Lot53
PhaseRC
Model-Windsor (42-03) Elev B
MUKESHBHAI PATEL

Colours Upgrade Report

FRONT ELEVATION 'A' MODIFIED
FOR LOT 53

**FINAL STRUCTURAL REQUEST
ACKNOWLEDGMENT**

SECOND FLOOR
ELEVATION A

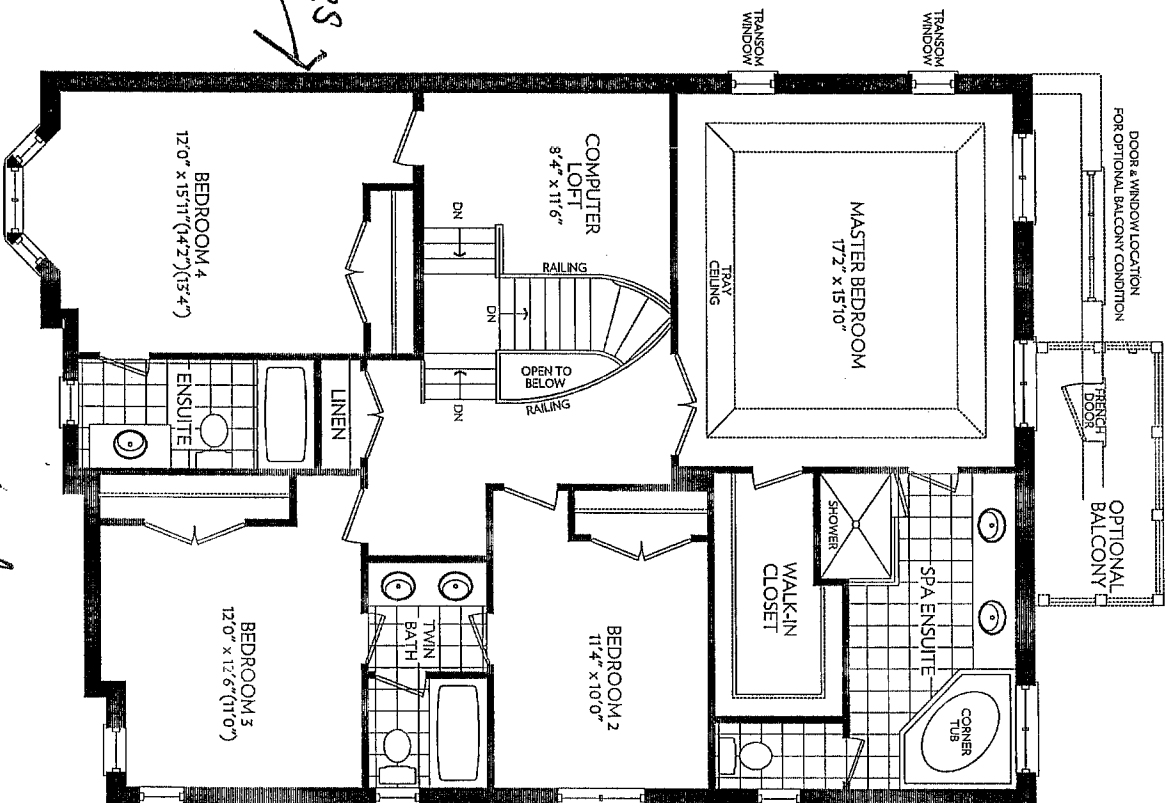
ALL
DOORS TO
2ND FLOOR
7 FT. HIGH
Hollow Doors
